MEETING ON RECALCULATION OF
SEISMIC RESPONSE SPECTRA:
COMANCHE PEAK

Location: Bethesda, Maryland
Date: Tuesday, June 18, 1985

1 UNITED STATES OF AMERICA
2 NUCLEAR REGULATORY COMMISSION
3
4 MEETING ON RECALCULATION OF SEISMIC RESPONSE SPECTRA:
5 COMANCHE PEAK

AUXILIARY BUILDING
FLOOR RESPONSE SPECTRA
FSAR vs RSI RE-ANALYSIS

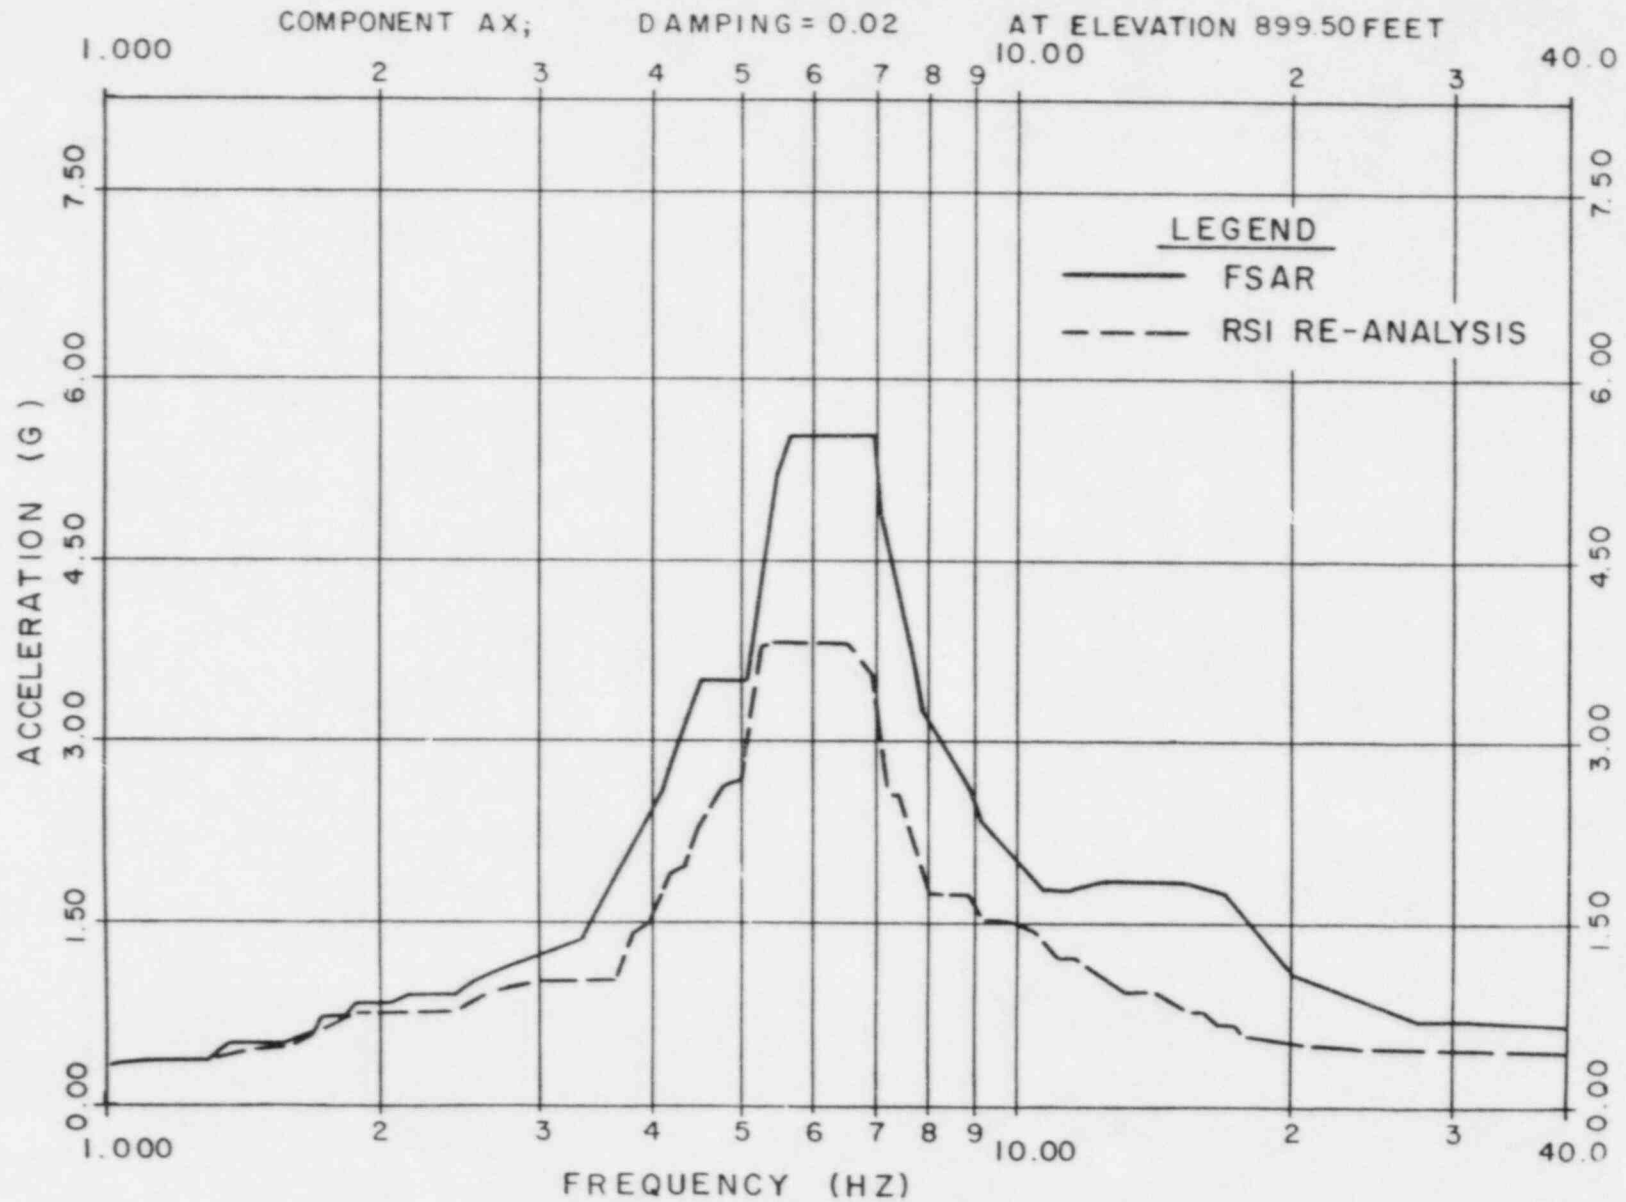
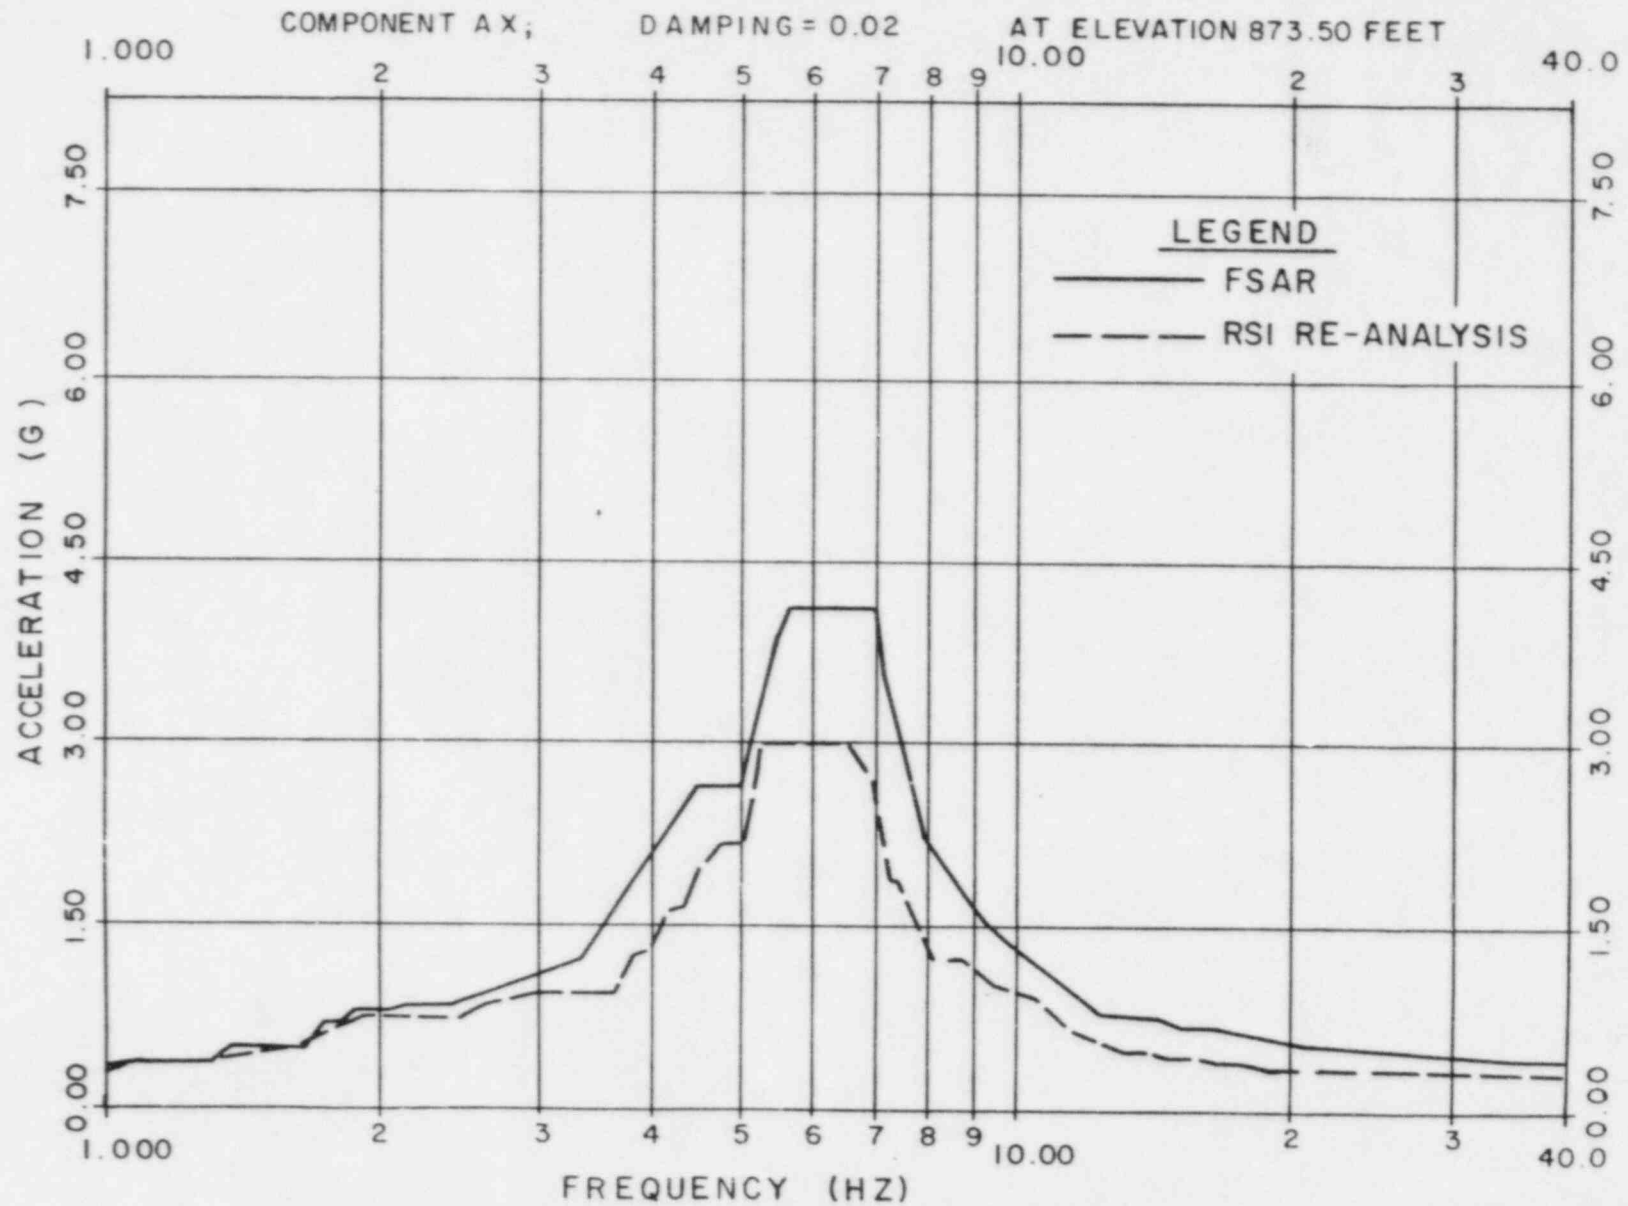
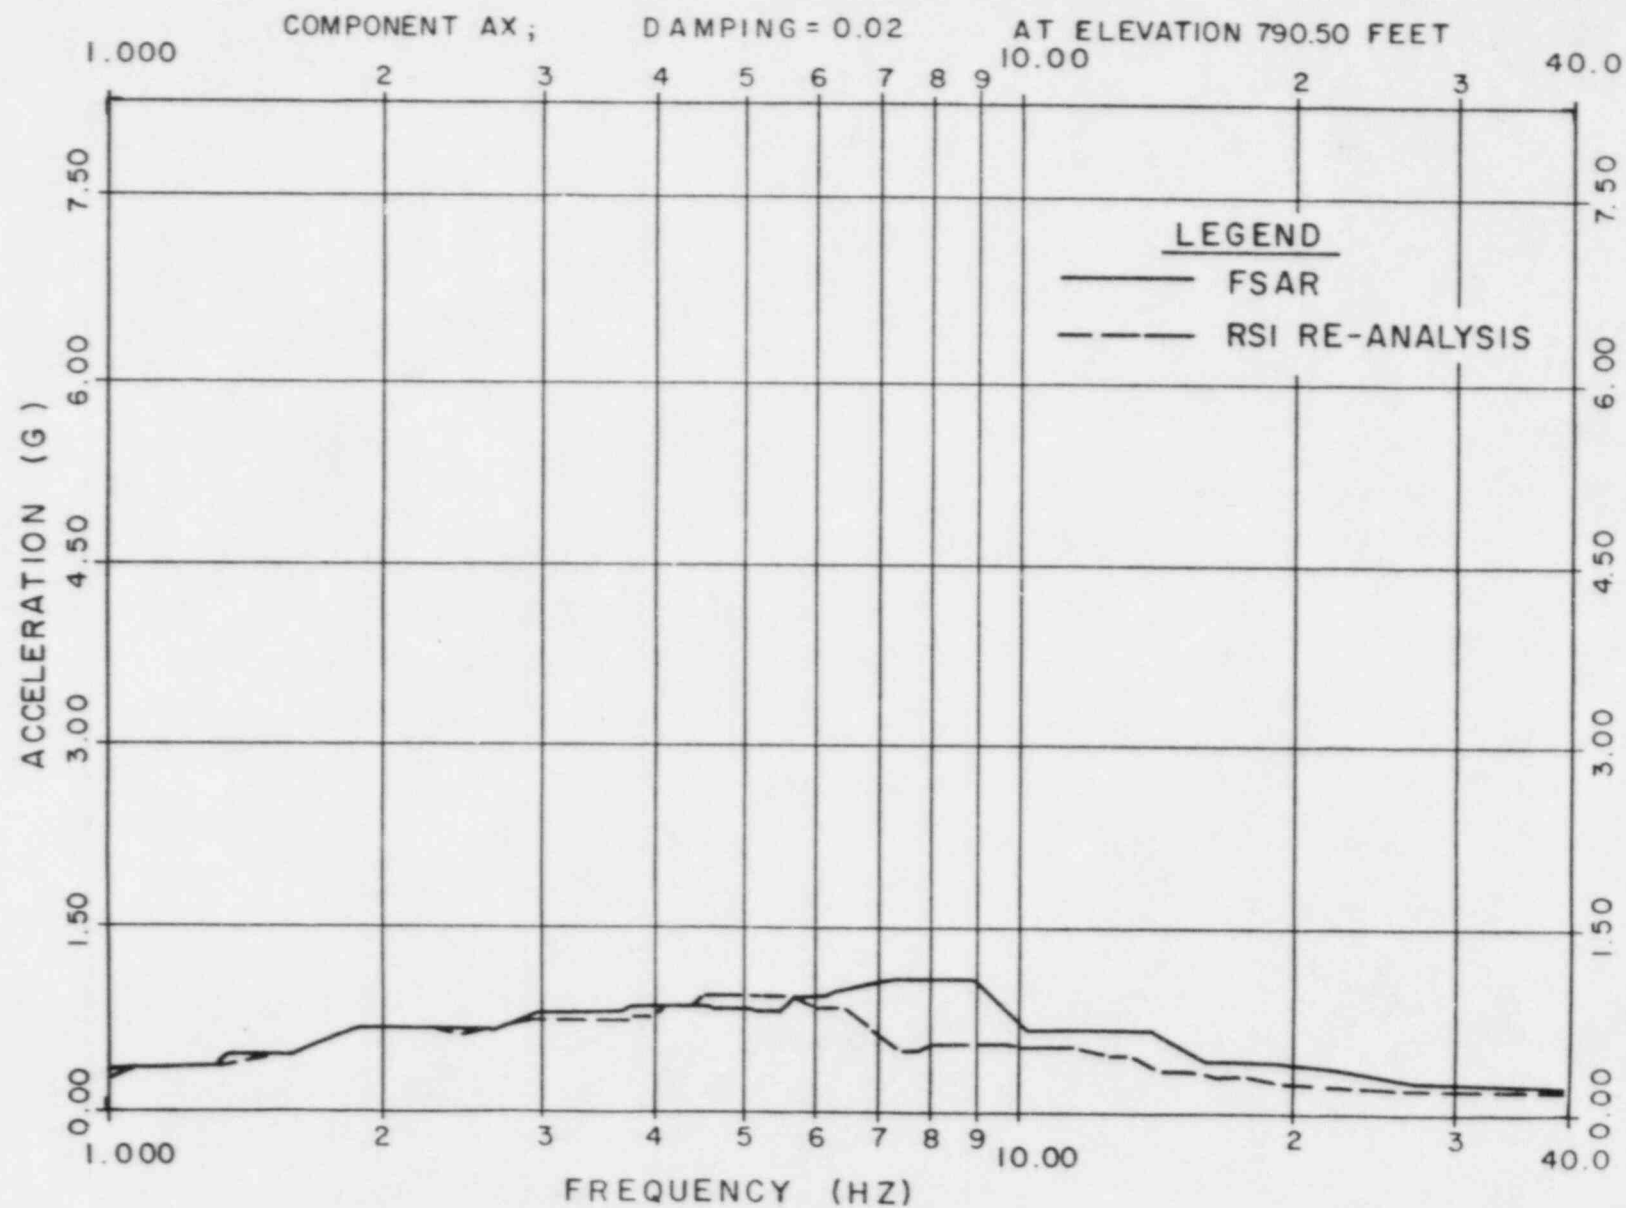
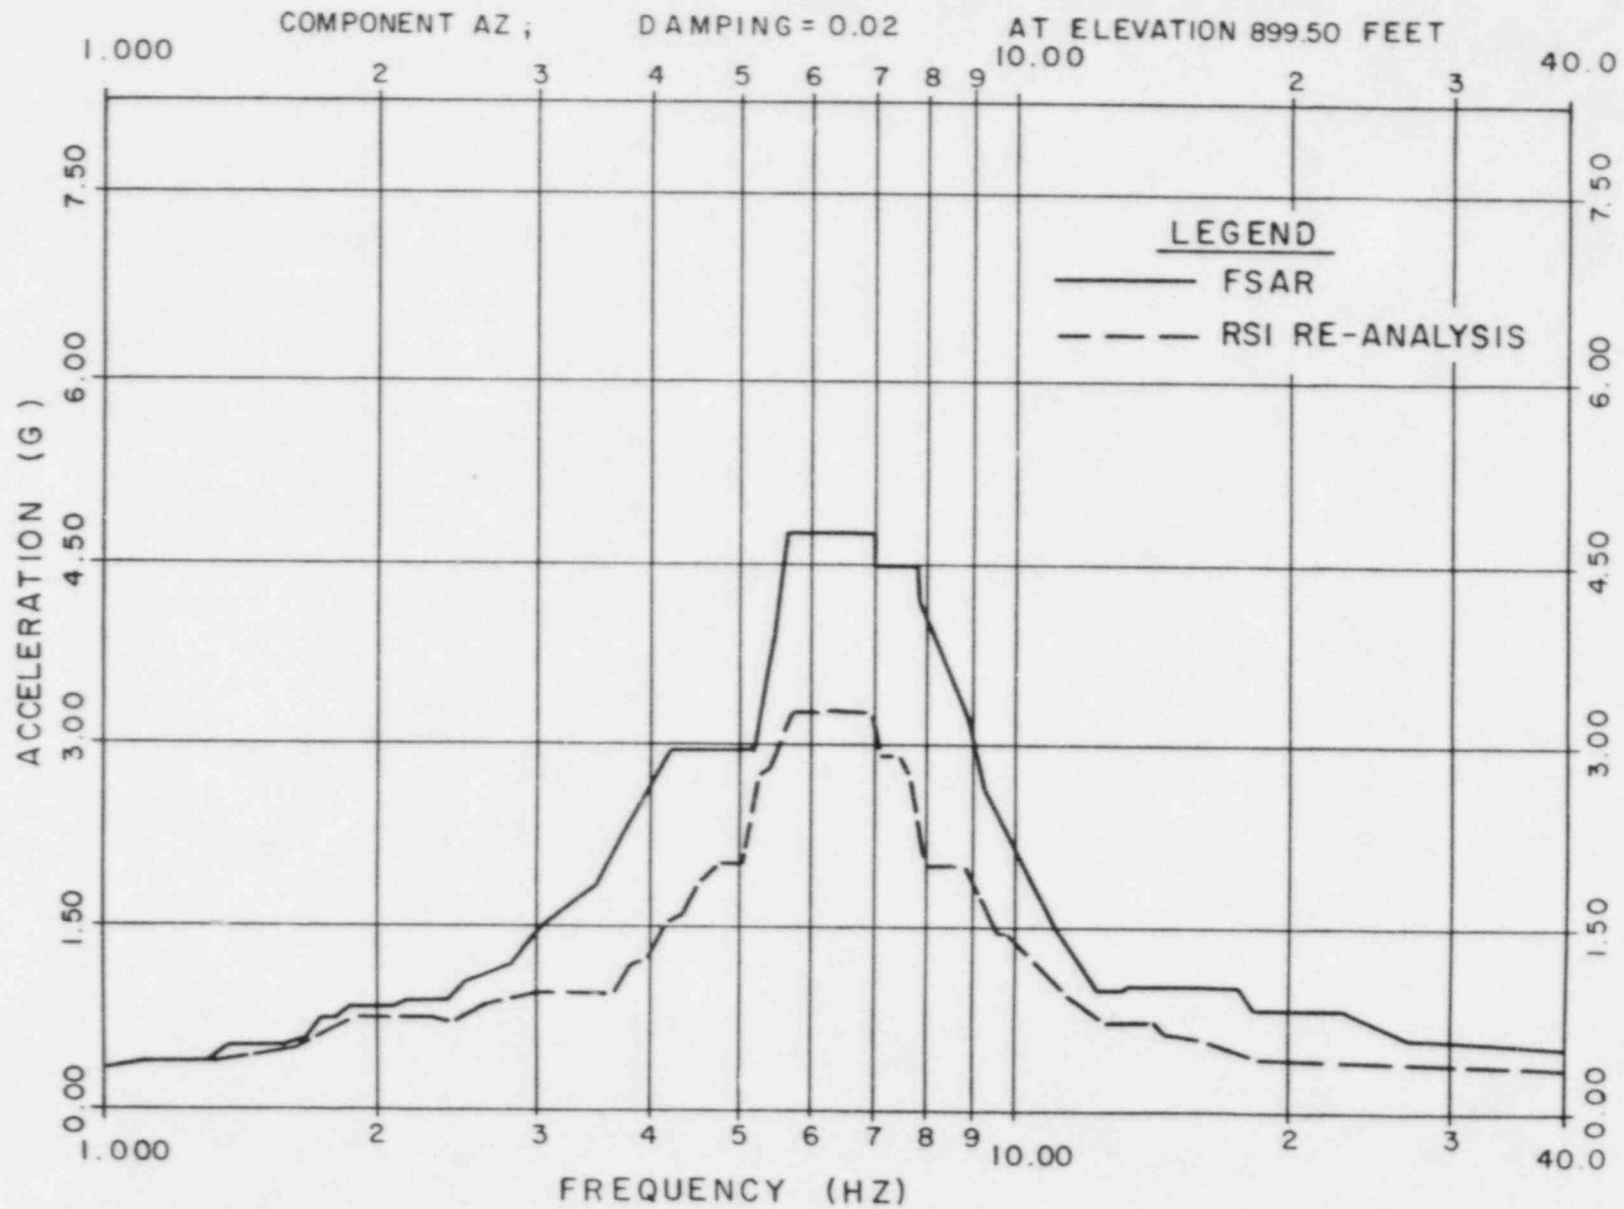
22 Now, in response to Larry Shao's comment earlier,
23 you can see that across this particular elevation, this
24 particular direction, we are below our previous response
25 spectra at all points except here [indicating], at about 1.8

16 Here the frequency shift occurs. We have a slight
17 overage on the response spectra.

16 MR. RINALDI: I have two short questions. One, you
17 refer to peak broadening. You use plus and minus 10 percent.
18 I want to caution you that the new requirement is 15 percent
19 unless you can prove otherwise. Just a comment.

20 The other thing is a question basically on the
21 spectra you showed for 2 percent damping. Can you comment on
22 5 percent damping? Is there significant change from what you
23 show?

18 MR. CLOUD: On the issue of the peak broadening, I
19 guess we have felt that the Standard Review Plan was slightly
20 different than you stated it. We felt that it called for 15
21 percent, but that 10 percent would be acceptable, provided it
22 was justified with additional studies.

2 In our view, that satisfies this approach
3 (indicating). Any reasonable method for determining the
4 amount of peak widening, and we add 10 percent on top of
5 that. It says "plus or minus." We take 10 percent on top of
6 the widening.
